**Item 2**
**6 Nerang Street Ryde - LDA2021/0379**
**New dual occupancy (attached) and Torrens Title subdivision**
**Report prepared by:** Senior Coordinator - Development Assessment

**City of Ryde  
Local Planning Panel Report**

The subject development application (LDA2021/379) was lodged on 1 November 2021 and seeks consent for the construction of an attached dual occupancy and Torrens title subdivision.

**Figure 10** Section 1 showing three storey elements

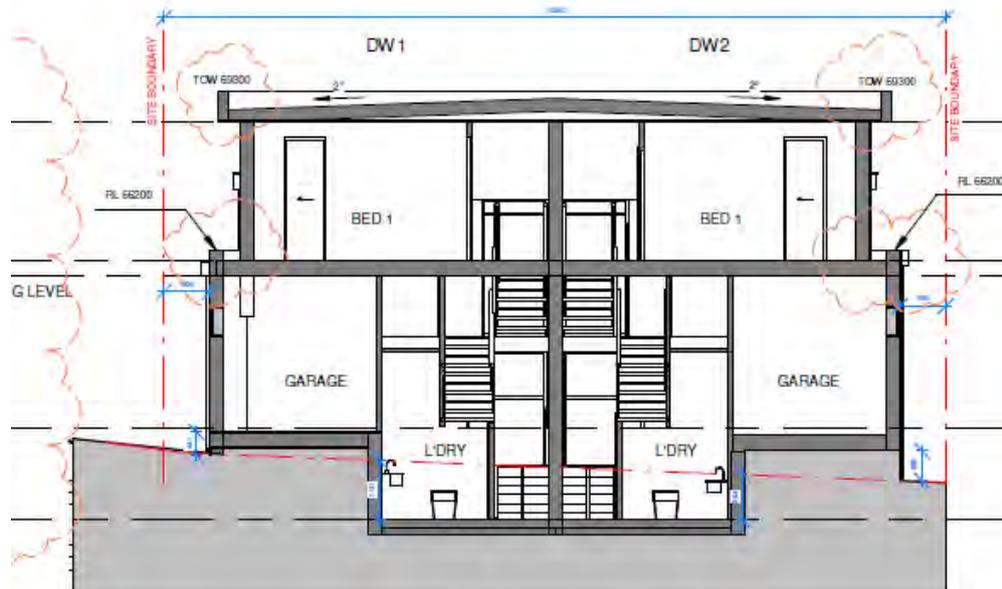
Whilst the majority of the proposed building is two storeys in height and achieves compliance, there is a portion of the building located at the transition of the split levels

where the height is regarded as being three storeys (at the location of the laundries), which is depicted at **Figure 10** below:

- As depicted in Figure 10, the laundries are significantly excavated into the site (up to 1.161 metres), towards the centre of the building footprint and the three storey height will not be read at the exterior of the building.
- The three storey height only occurs at the transition of the split levels and the building maintains a two storey height for the remainder of its form.
- The laundries can be considered as a half storey as their finished floor levels are situated only 1.7 metres below the finished floor levels of the garages.
- The built form appears as two storeys as viewed from adjoining properties and from the public domain.

**Figure 11** Section demonstrating fill beneath the garage and alfresco.

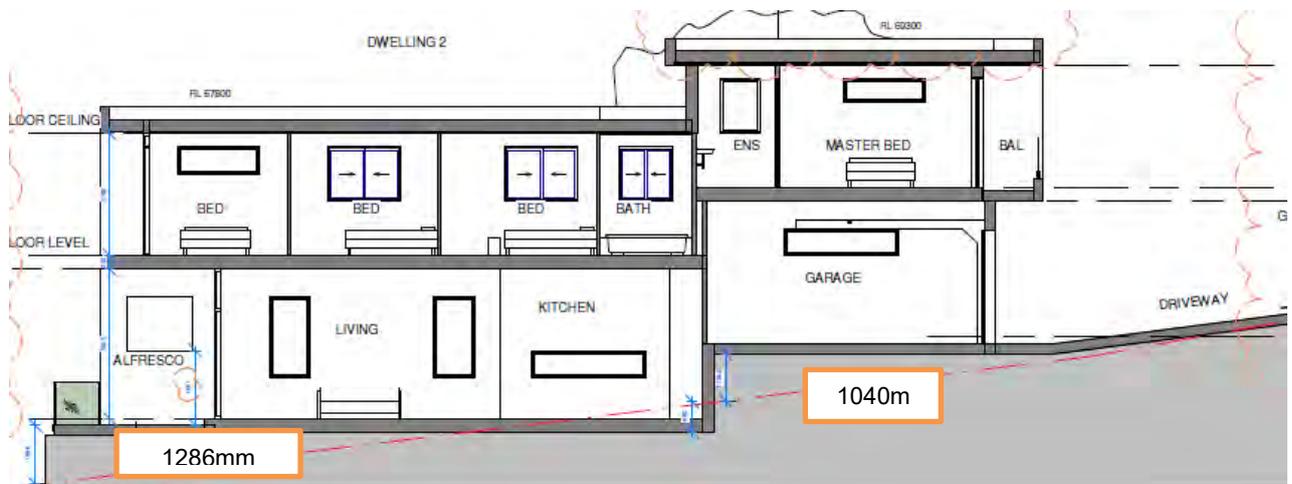
- The fill is located beneath the garages and a small portion of the rear alfresco areas as demonstrated in Figure 9. The site has a diagonal cross fall and the proposal has responded to the topography including a split-level design to minimise cut and fill across the site.

**Figure 12** North-western elevation showing the portions of the building exceeding the 8m wall plate height in yellow.

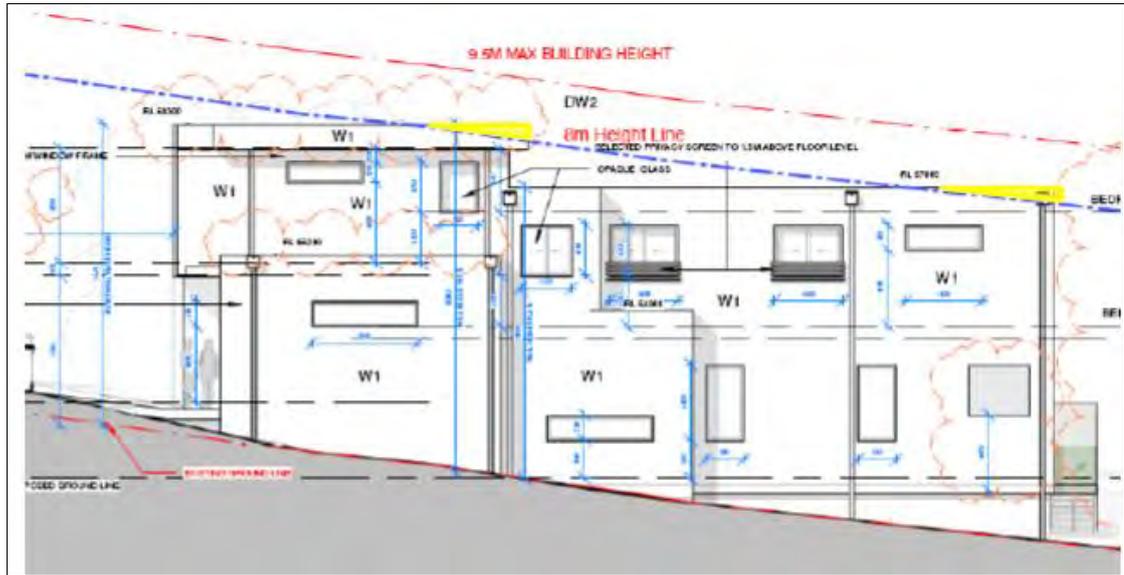
Control 2.8.1(a) outlines that the maximum permitted wall plate height is 8m to the top of the parapet. The maximum proposed wall plate height is 8.24 metres along the north-western elevation (**Figure 12**). The proposal is considered acceptable for the following reasons:

- The rear area of non-compliance has a side setback of 2.1 metres which exceeds the minimum required 1.5 metres.
- The areas of non-compliance given the increased front setback will not be perceived from the streetscape.

**Figure 14** Amended first floor balconies

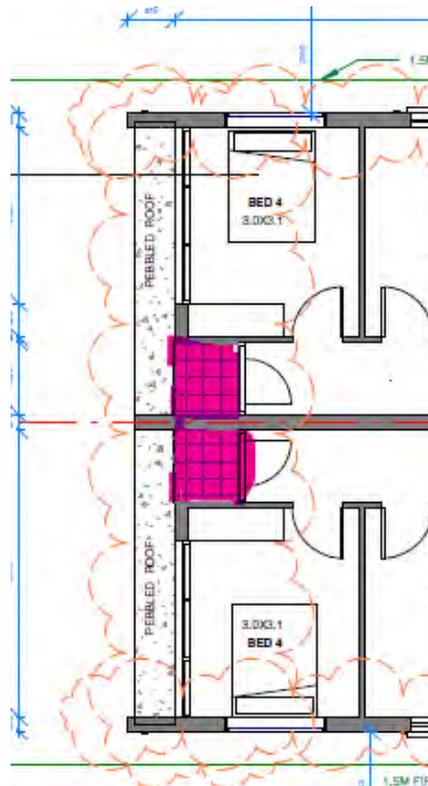
Comment: The proposal has been amended to significantly reduce the scale of the first floor rear balconies. The first floor balconies originally had a depth of 1016mm with a return between the proposed dwellings. The amended plans have deleted the first floor balcony now proposing a 816mm deep pebbled roof with the balcony return between the dwellings maintained. The return has a width of 1300mm and is offset from the side

boundaries (**Figure 14**). The proposed first floor balconies do not result in any adverse privacy impacts.

Comment: The proposal has been amended to significantly reduce the scale of the first floor rear balconies (**Figure 14**). They are now of a scale that would prevent congregating or sitting for long periods. With regard to the elevated ground floor alfresco areas, the plans have been amended to increase the sill height of the alfresco windows on the side elevations to 1.8 metres. Given the nature of the use of alfresco areas, it is considered that further privacy screening of these window openings is warranted. **Condition No. 1(a)** requires amended plans prior to the issue of a Construction Certificate depicting privacy screens being fitted to these window openings.

**Figure 15** Shadow diagrams for 9am, 12 noon and 3pm mid-winter

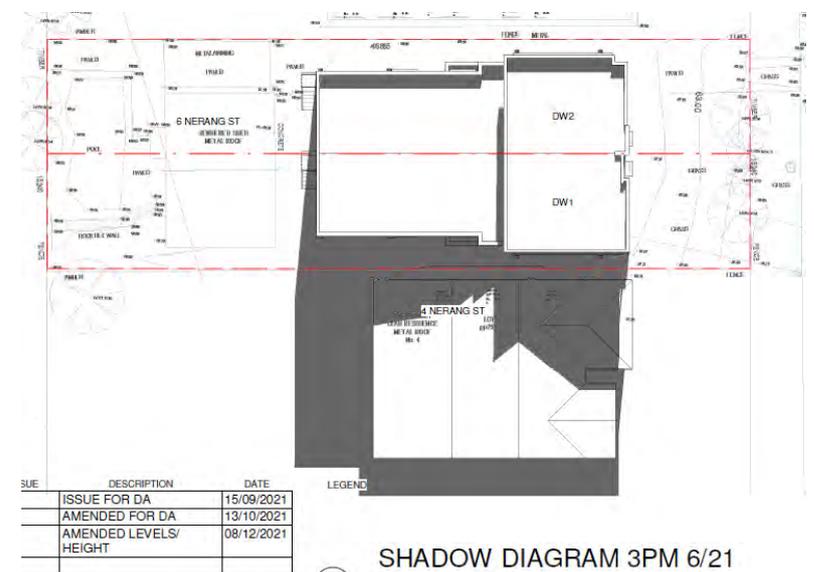
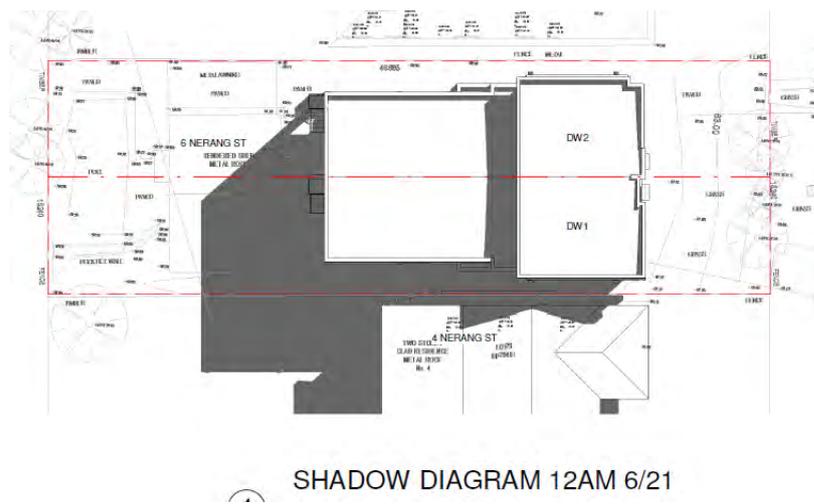
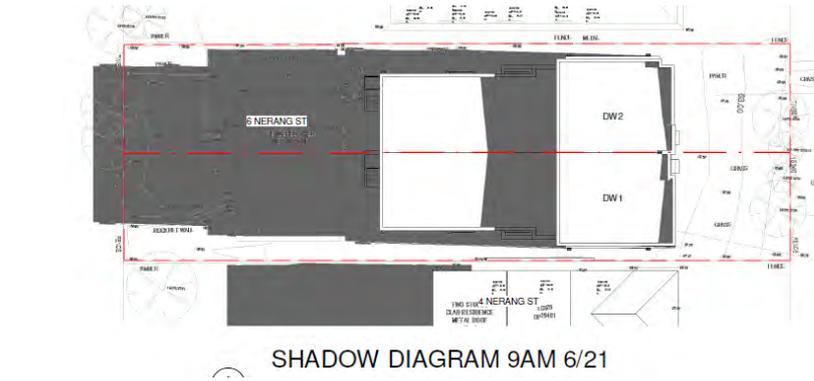
- sunlight to at least 50% of the principal area of ground level private open space of adjacent properties is not reduced to less than two hours between 9 am and 3 pm on June 21; and*
- windows to north-facing living areas of neighbouring dwellings receive at least 3 hours of sunlight between 9 am and 3 pm on 21 June over a portion of their surface, where this can be reasonably maintained given the orientation topography of the subject and neighbouring site*

The proposal still allows for solar access to over 50% of the ground level private open space of No. 4 Nerang Street (to the rear of the dwelling) for more than 2 hours between 9am and 3pm on June 21. The dwelling at No. 4 Nerang Street does not contain any north-facing living areas, rather, the north-facing rooms comprise bedrooms, as a result, the submission of elevational shadow diagrams addressing this dwelling was not considered to be warranted. The proposal achieves compliance with the DCP with regard to solar access for the neighbouring dwelling.
